Supplementary Arboricultural Impact Assessment Report

Village 5 Playground, Jordan Springs,
NSW

Prepared for:
Clouston Associates

14 September 2015

ANNEXURE 1 - TREE LOCATION PLAN

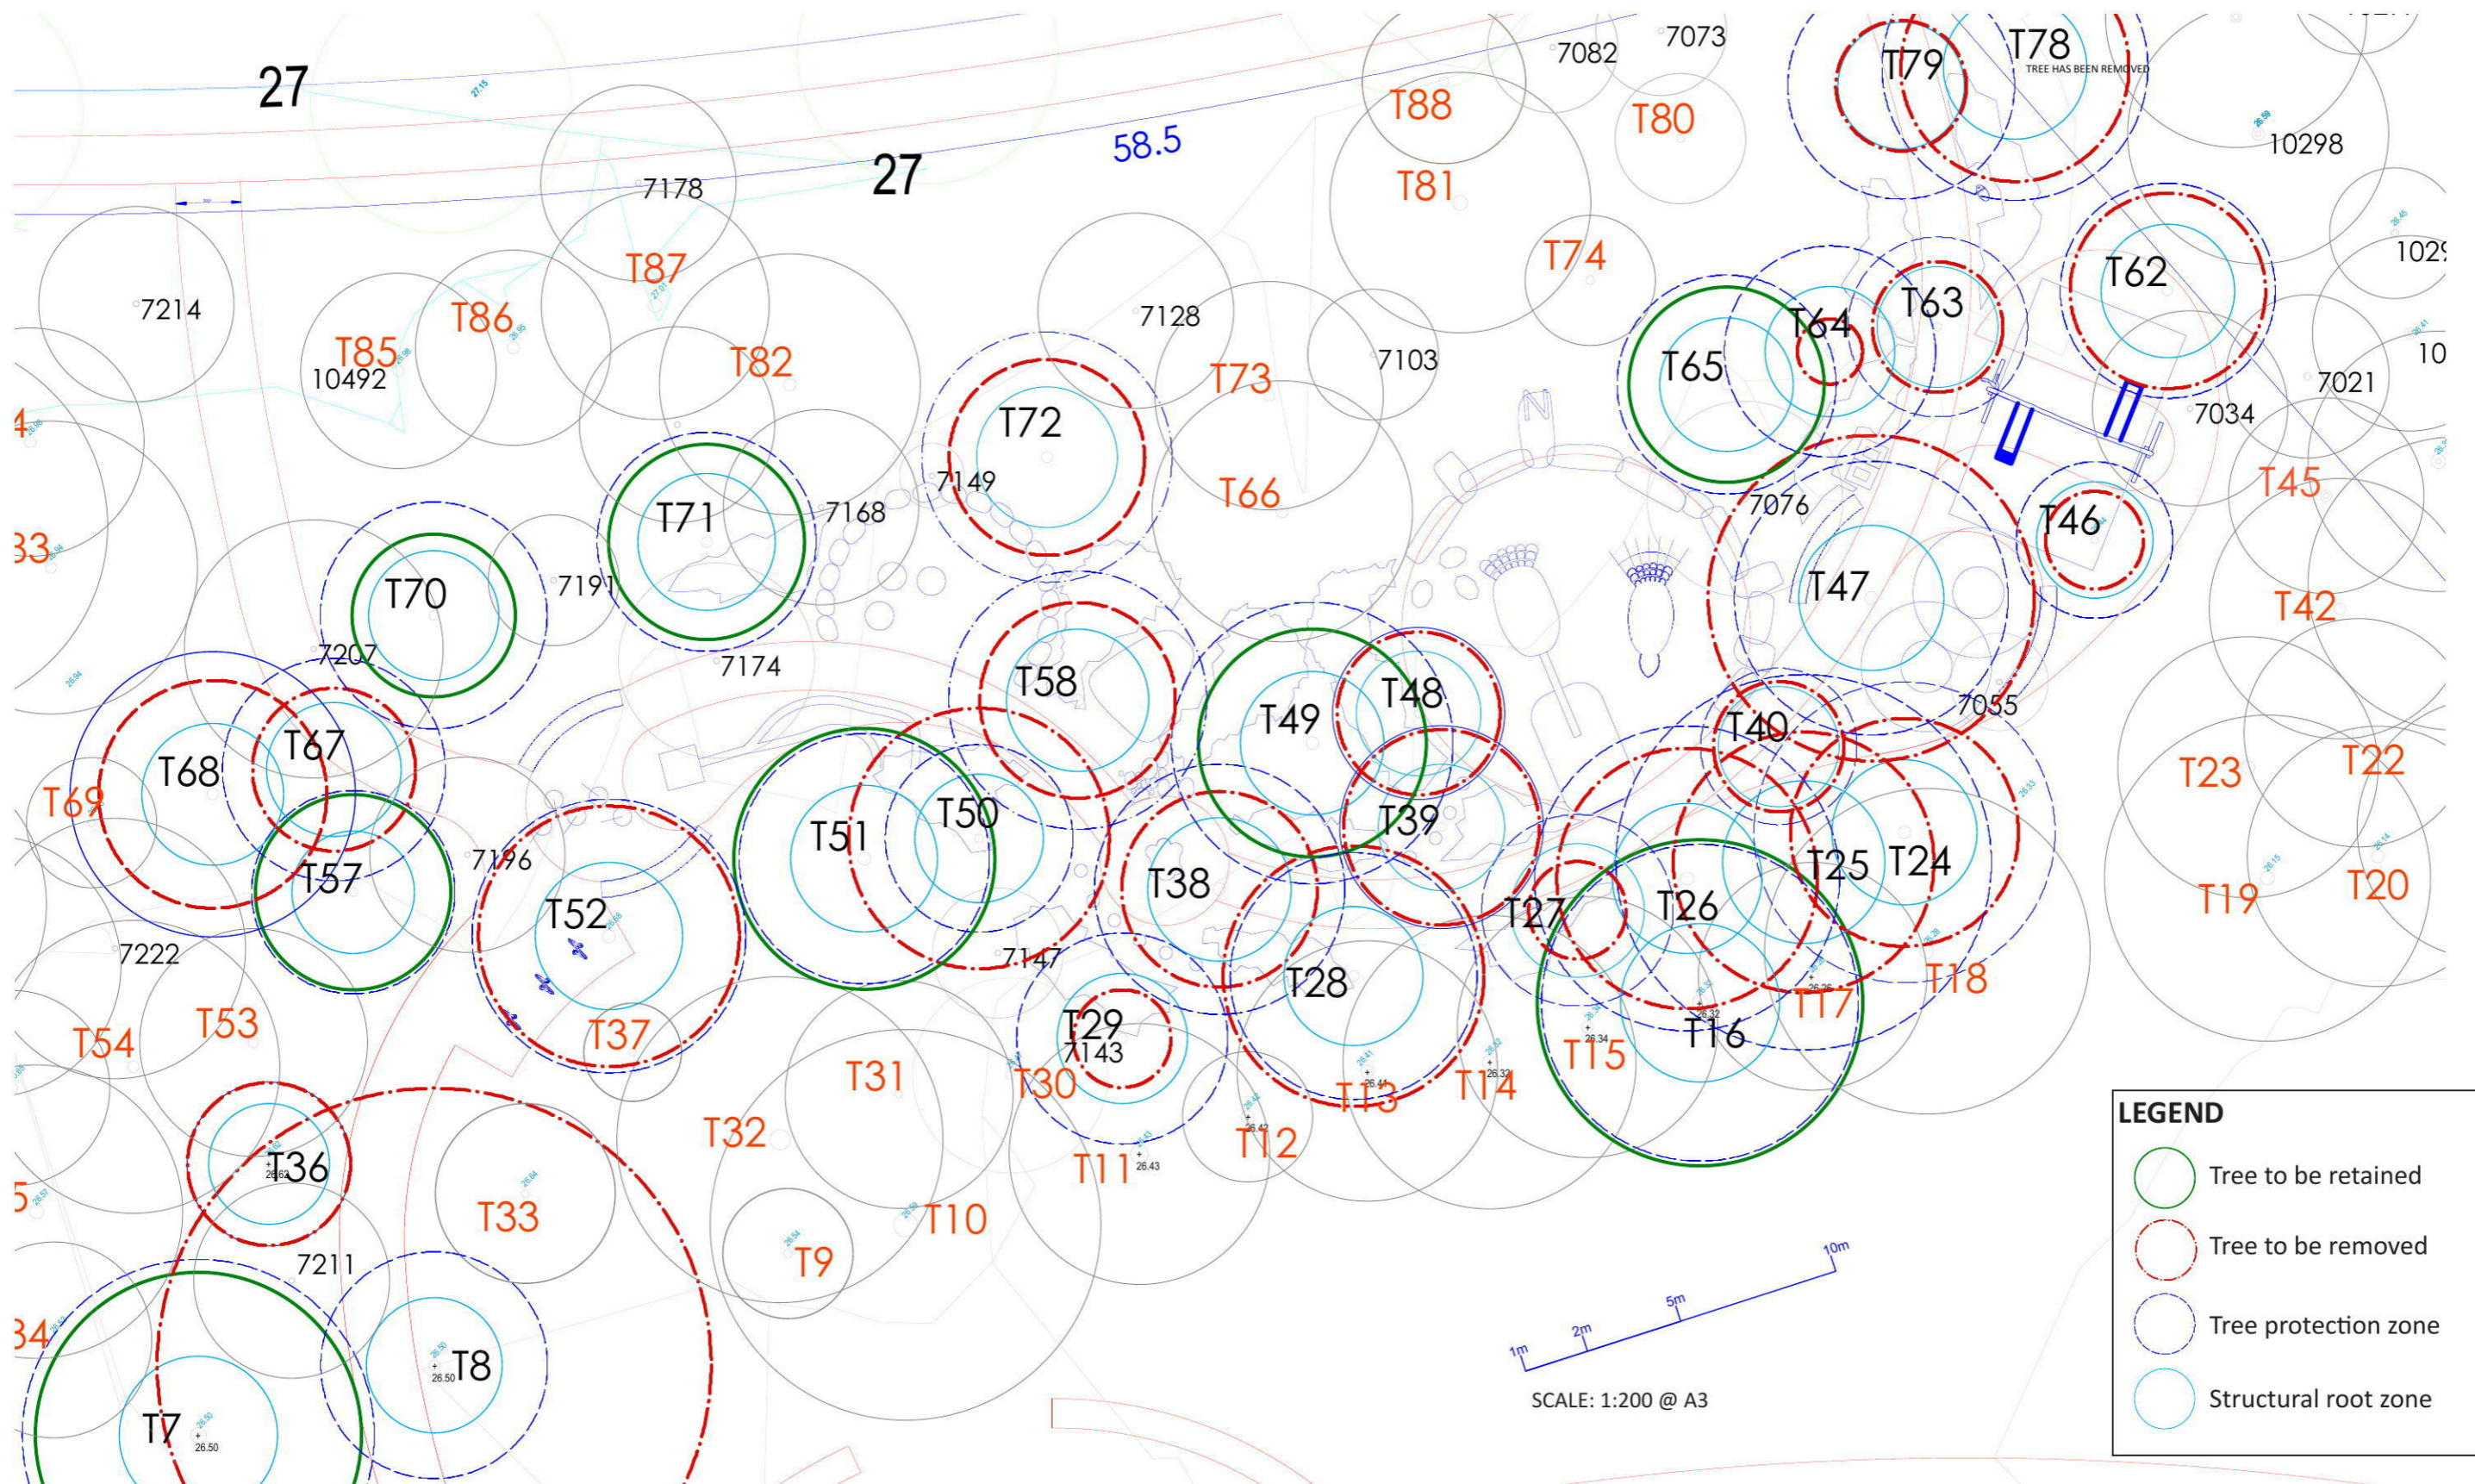
Tree 7 - A less than 1% incursion to the tree protection zone (previously none) due to a change in the route of the concrete path to the west of the playground. This is considered to be a minor encroachment under AS 4970 - 2009. The Arborist Report states that the tree is in good health and good condition, has medium landscape significance, medium amenity value and high ecological value. Based on this information the tree should be retained.

Tree 8 - A 47.6% incursion to the tree protection zone (previously 39.1%) and 35% incursion to the structural root zone by the concrete path because of the change in location. Although the Arborist Report states that the tree is in fair health it is unlikely to survive this significant level of incursion and will need to be removed.

Tree 24 - A 10.6% incursion to the tree protection zone (previously 36.3%) from the rubber softfall around the trampolines. Despite the moderate level of incursion the Arborist Report records that the tree is fair to average health and has bottle butt. The tree should be removed.

Tree 26 - The proposed changes slightly reduce the incursion to the tree protection zone of this tree from 28.3% to 24.9% due to excavation for both rubber and mulch softfall. This is still a high impact and the tree may not survive. The proposed works also encroach into the structural rootzone by 10%. The Arborist Report records that the tree is in poor to fair health only with visible structural defects. The tree will need to be removed.

Tree 27 - An increase in the incursion to the tree protection zone from 9.6% to 30.9% due to excavation for the rubber softfall path. This is a significant impact and the tree is unlikely to survive. There is also a 24.2% incursion in the structural root zone of this tree which may destabilise the tree. The Arborist Report states that the tree is in poor health and poor

Tree 28 - An increase in the incursion to the tree protection zone from 20.1% previously to 25.9% and an 18.3% incursion to the structural root zone of the tree caused by excavation for the rubber softfall path. This is a high level of incursion and the tree may not survive. The tree may be destabilised and will need to be removed.

Tree 38 - The tree now lays within the footprint of the circular area of concrete paving under the frog (100% incursion to both the tree protection zone and structural root zone, previously 38.6%). This tree will need to be removed.

Tree 39 - A 100% incursion to the tree protection zone due to the steppers with native insects which will go through the centre of the stem, the other elements comprising a 25.9% incursion (previously 35.7%). The Arborist Report states that the tree is in poor health and fair condition with visible structural defects, deadwood to 60mm in diameter, low landscape significance and low amenity value. The tree will need to be removed.

Tree 46 - The tree lays within the footprint of the rubber and mulch softfall areas close to the swings (a 100% incursion to both the tree protection zone and structural root zone of the tree, previously a 37.6% incursion to the tree protection zone). The Arborist Report notes that the tree is in poor health and average condition with minor structural defects and extensive epicormic growth. The tree will need to be removed.

Tree 48 - An incursion of 32.4% (previously 20.5%) to the tree protection zone and an incursion of 35.8% to the structural root zone caused by the circular mulch softfall area under the heron climbing structures. This is a significant impact and the tree is unlikely to survive. The high incursion to the structural root zone may cause the whole tree to fail. The Arborist Report states that the tree is in poor health and fair structural condition with minor structural defects and poor form. The tree has low landscape significance and low amenity value. The tree will need to be removed.

Tree 58 - A 37.1% incursion to the tree protection zone (previously 17.3%) and a 29.6% incursion to the structural root zone of the tree due to the sandpit and rubber softfall path. The Arborist Report states that the tree is in good health and good condition and has high ecological value. The incursion to the tree protection zone is significant and the tree is unlikely to survive. The high incursion to the structural root zone could destabilise that tree. The tree will need to be removed.

Tree 67 - A 47% incursion to the tree protection zone (previously 18%) and a 45% incursion to the structural root zone due to the amended route of the concrete path to the west of the playground. The path is located immediately to the east of the stem of the tree. The tree will not survive such a severe incursion and will need to be removed. The Arborist Report states that this tree is in average health and poor condition with significant structural defects. The tree has a low landscape value and low amenity value.

Tree 72 - A 13.7% incursion to the tree protection zone (previously none) and a very minor (less than 1%) incursion to the structural root zone of the tree due to the construction of the sandpit. This is considered to be a major encroachment under AS 4970 - 2009. The Arborist Report states that the tree is in poor to fair health, fair condition with 15-20% deadwood in the crown, has a low landscape significance and low amenity value. Trees in fair to poor health which are impacted by such disturbance will generally decline over a period of years following the disturbance (development works). As trees decline, dieback and deadwood increase in the canopy with increased risk of falling branches. The tree will need to be removed.

Of the 33 trees assessed, eight have been identified for retention and protection and 24 trees will be will require removal. One tree (Tree 78) has already been removed.

As a consequence of the amendments to the proposed design eight trees should be retained, and 17 trees will need to be removed. In addition, seven trees should be removed irrespective of changes to the design. These trees are identified in Tables 1 and 2 below.
